Detailed Site Plan DSP-16037-03
Zaxby's Brooks Drive

REQUEST	STAFF RECOMMENDATION
Development of a 2,064-square-foot eating or drinking establishment with drive-through service on Parcel 4.	With the conditions recommended herein: • APPROVAL of Detailed Site Plan DSP-16037-03

STAFF REPORT

SUBJECT: Detailed Site Plan DSP-16037-03
Zaxby's Brooks Drive

2/9 ZAXBYS DOUBLE SIDED MONUMENT SIGN
SCALE: NTS
Base Height= 4'-0"
Sign Height= 7'-8"
Total Height= 15'-0"
Lighting: Internal

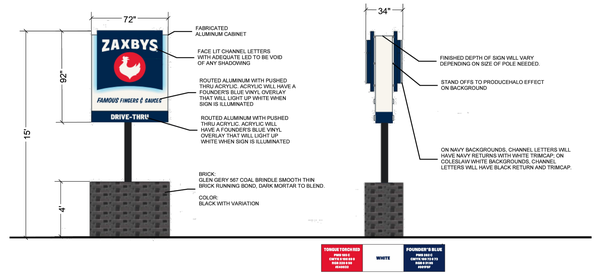
details are included on Sheet 9 of the DSP. However, the distance between the freestanding sign and limits of MD 4 is not labelled, which is conditioned herein to be provided. Pursuant to Section 27-591(b) of the Zoning Ordinance, "only the larger of two (2) sides shall be measured when the two (2) sides of a sign are back-to-back." A condition is included herein requiring the applicant to revise the signage chart to correctly note the provided area of the freestanding sign as 46 square feet.

3/11 ZAXBYS DIRECTIONAL SIGNAGE
SCALE: NTS

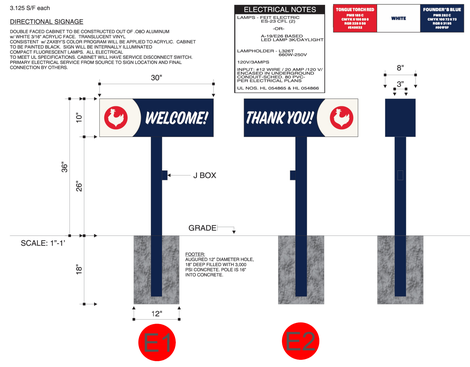
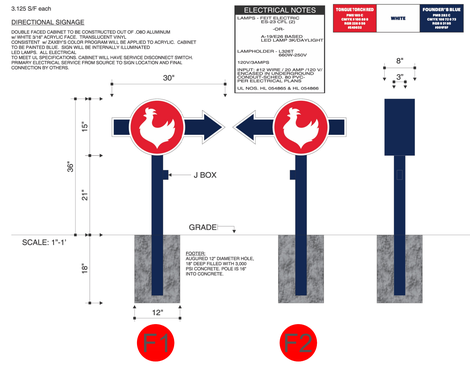
d. Pursuant to Section 27-445.15(b)(3) of the prior Prince George's County Zoning Ordinance, revise the area of the Type E sign to 2.083 square feet in the sign detail 3/11.

3 DUMPSTER ENCLOSURE GATE DETAIL

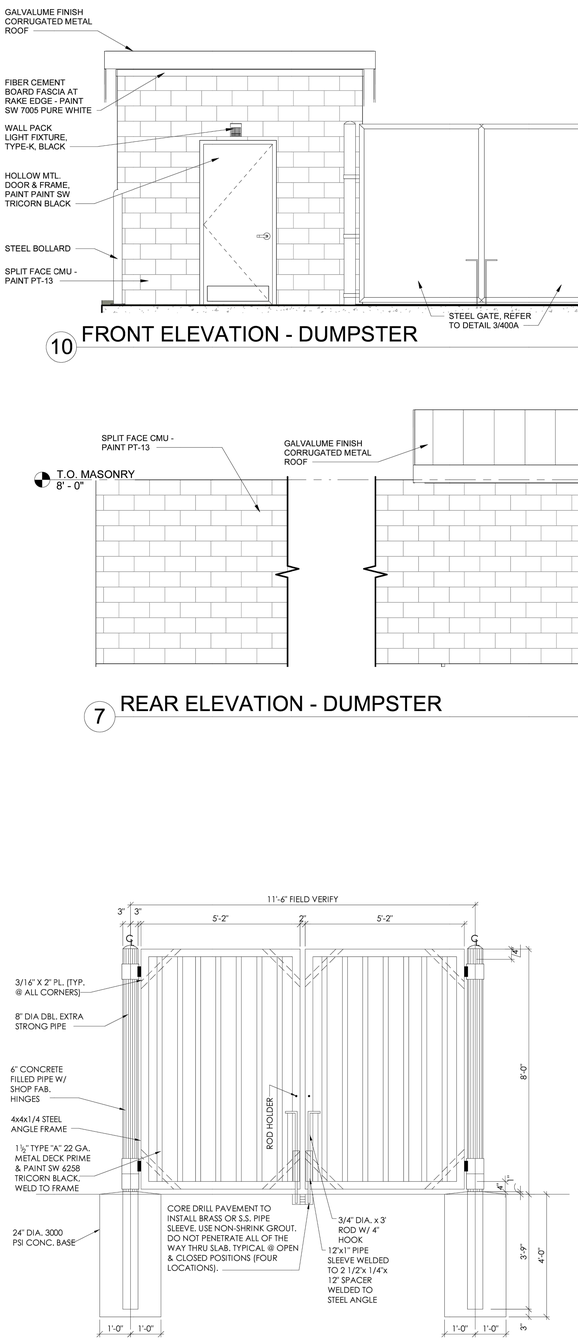
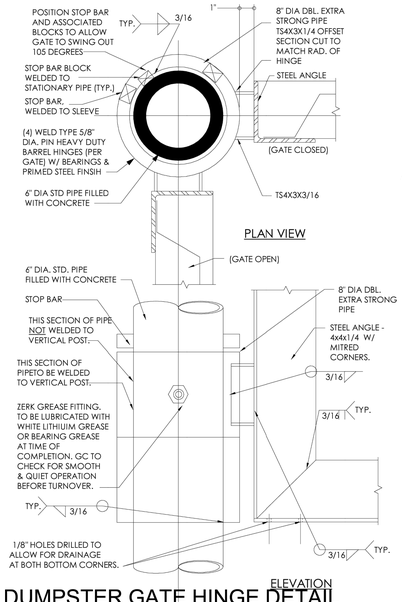
i. Indicate and provide detail for signage on the dumpster gate, to keep the dumpster doors closed, pursuant to Section 27-274(a)(2)(B) of the prior Prince George's County Zoning Ordinance.

4 NORTH ELEVATION

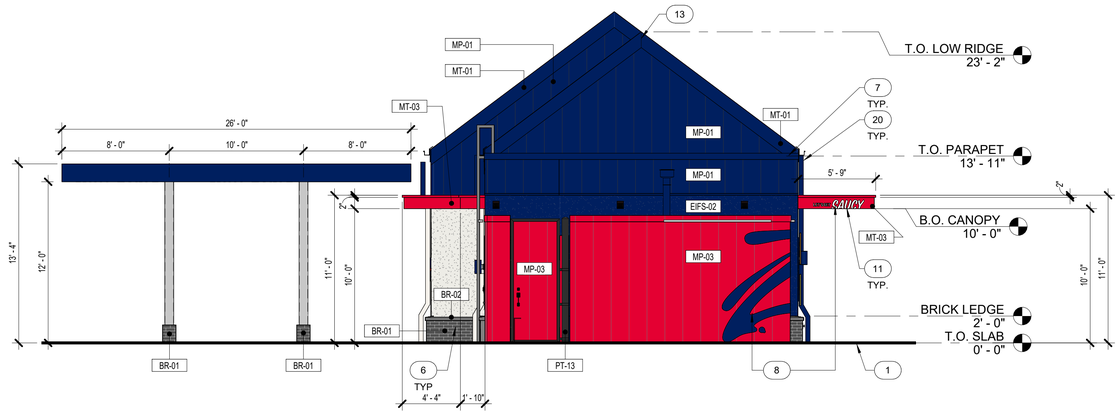
j. Revise the architectural floor plan DD-01 to add a door symbol for the electrical area, ensuring consistency with the northern elevation.
